**Name of Project** Building permit for hotel proposed by 20 Central Street LLC

Street Address of Project/Action 20 Central Street Map: 29 Lot: 293

**RE: Appeal of Building Permit; 20 Central Street, LLC**

**ROCKPORT HARBOR HOTEL**  
20 Central Street, Rockport, ME 04856

**SOUTH ELEVATION**

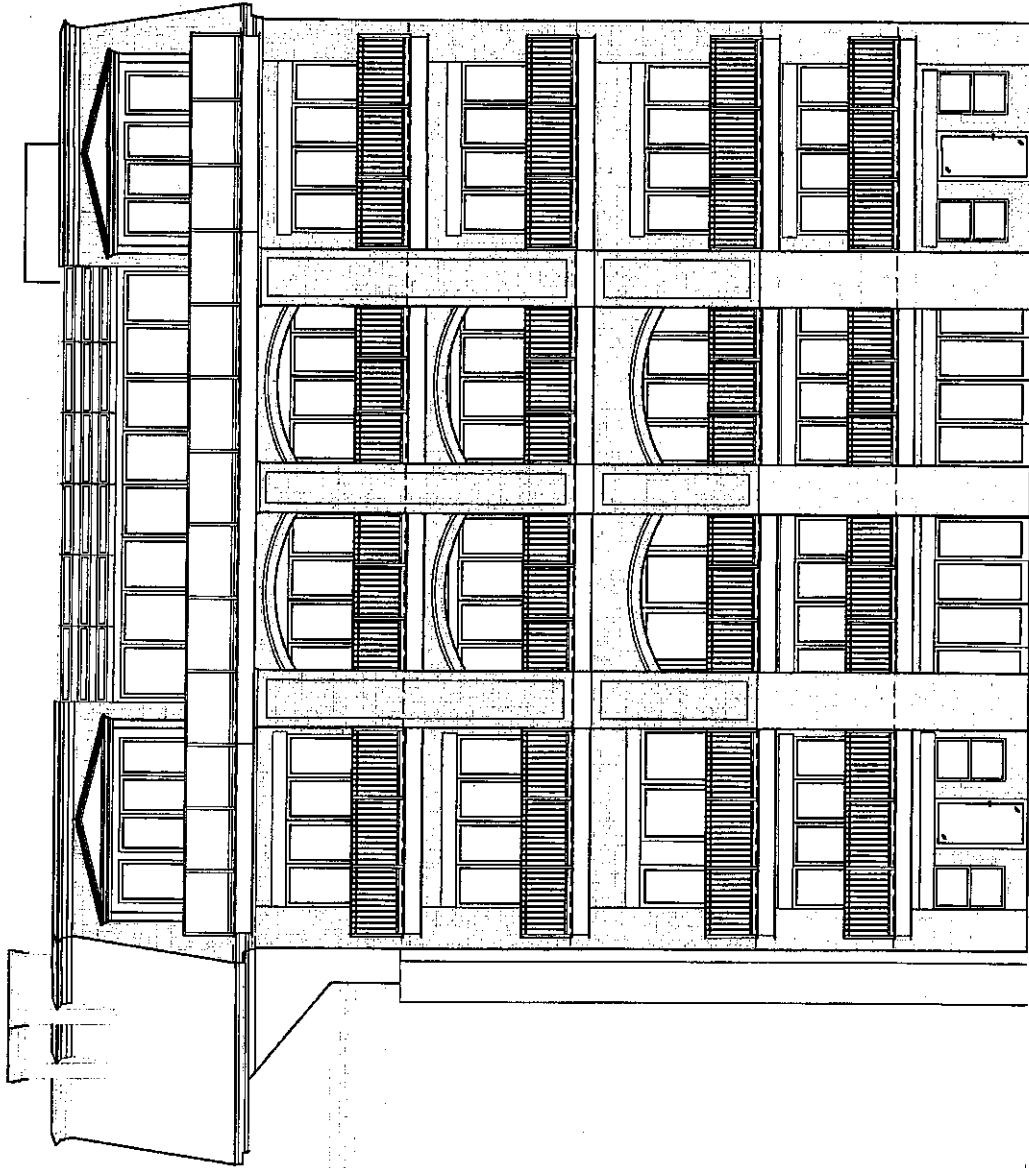
1. The hotel is not “located and configured in a visually harmonious manner with the terrain and vegetation of the parcel and surrounding parcels.” “The architectural design of [the structure] and [its] materials and colors” is not “visually harmonious with the overall appearance of neighboring structures.” The hotel is being located on a block of structures that are all very similar in era and design, but as designed it contains many architectural elements which are not harmonious with those other structures. This is especially problematic given Rockport Village’s designation as a historic place deserving of extra protections. For reference, see exterior building plans attached as Exhibit B.

- a. The balconies on the front and rear are incongruous with the rest of the block. There are no current protrusions on the front of the block, which overlooks private residences on Central, Franklin and Main Streets. The back of the block currently features only a few modest decks.

- i. The façade of the building (both front and rear) has far more glass than on the other buildings on the block. The rear of the building overwhelms the more sedate, historic rear façades of the neighboring buildings and is visually imposing when viewed from the harbor.

- b. The elevations have been changed to show numerous “decorative columns” on the Central Street façade. These are both more numerous and of a substantially different design and character than shown on the elevations presented to the Planning Board. Remembering that this is a historic district, these changes are material to the issue of whether the design is in keeping with the architectural character of the block. Such columns are not found anywhere on Central Street.
- c. The building plans show numerous other differences from the elevations presented to the Planning Board:

- i. The elevations submitted to the PB showed arches over the porches on the lobby level; these are now gone.
- ii. The elevations to the PB showed consistent arch design between the lobby and top floors; they are now inconsistent.
- iii. The elevations to the PB showed four individual doors at the lobby level; the building plans show two doors and large folding glass doors at the center.
- iv. The elevations to the PB showed overhanging arched roofs matching the archways below; the building plans show peaked roofs with no overhang.
- v. The building plans show a large continuous balcony with railing panels at the top level that are either glass or opaque. These were not shown in the elevations submitted to the Planning Board.

**FOURTH FLOOR SEATING**

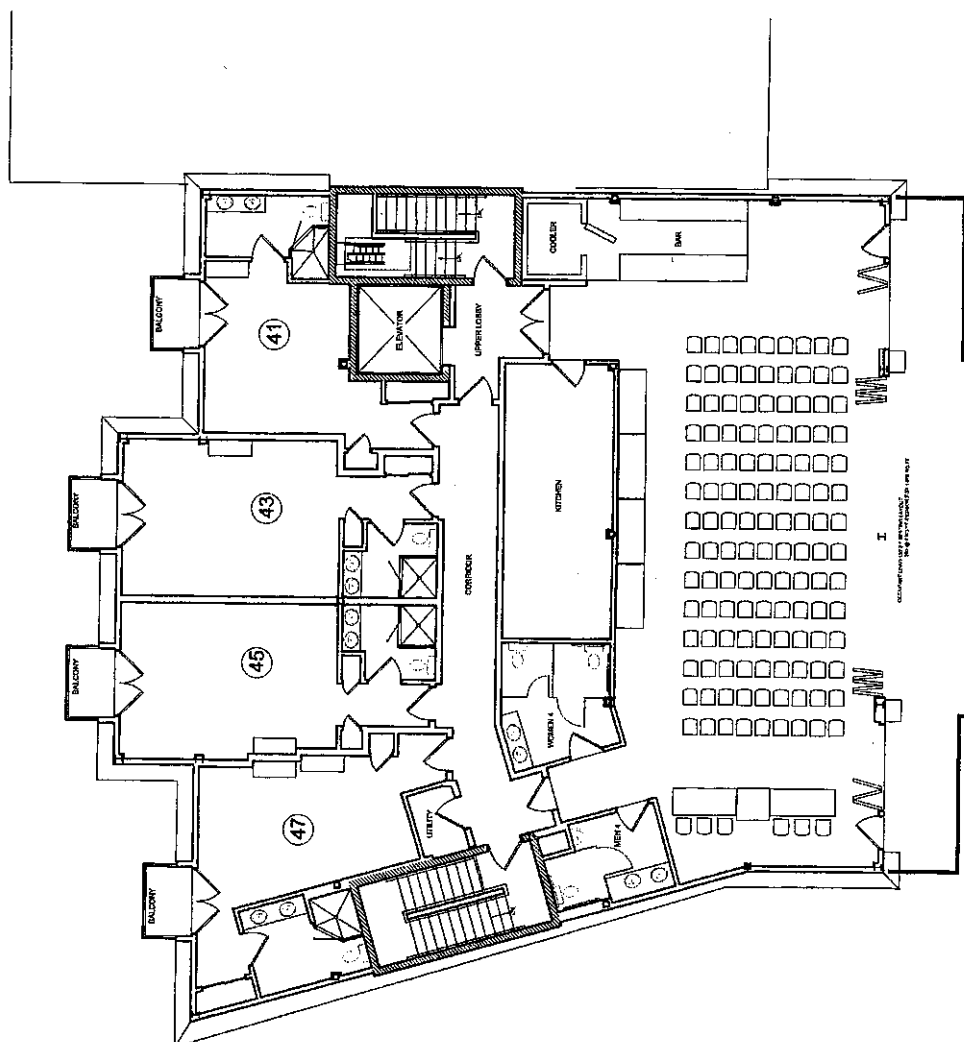
Drawings submitted by the Applicant depict an assembly use in the top-floor restaurant, showing 132 seats in a conference-style setting. (See Exhibit D). It is apparent that the Applicant's intention is to use this floor for weddings, events and business conferences, none of which were mentioned at all during the Planning Board's review. The applicant stated in its site plan application to the Planning Board that the top-floor restaurant would have 60 seats and require 20 parking spaces under the Land Use Ordinance. Under both the 2018 and 2020 versions of the Ordinance, "Places of Assembly" are a separately delineated use in the 913 Downtown District. Sec. 913.3(C). Under Section 803.1, assembly uses must provide one parking space for every four seats. The top-floor restaurant, as depicted, therefore requires the provision of 33 parking spaces, which means that it and the lobby restaurant, taken together, require the provision of 41 parking spaces, and not the 28 spaces the Planning Board considered.

This depiction of assembly use justifies denial of the building permit for several reasons. First, it represents a material deviation from the site plan approval, which was based on a total parking demand of 56 spaces. Pursuant to Section 1306, "[a]ll construction performed under the authorization of a building permit issued for development within the scope of this Ordinance shall be in conformance with the approved site plan." The site plan application did not depict or describe this assembly use, and therefore that use cannot be approved as part of the building plans. The building permit must either be denied or issued with a condition that no assembly use may be made of the restaurant space or of any other part of the hotel premises. Such use would create significant parking demand, all at once, that the Village cannot handle. Events were not contemplated in either the Planning Board's or ZBA's review of the offsite, valet parking arrangement. While hotel guests could better be encouraged to use valet parking, the hotel would have no control over the choices of event guests, who likely would want to park as close to the venue as possible. Those guests would all arrive and leave at approximately the same time, causing significant parking and traffic burdens on the village. Such use simply cannot be allowed without additional, thorough review by the Planning Board and ZBA.
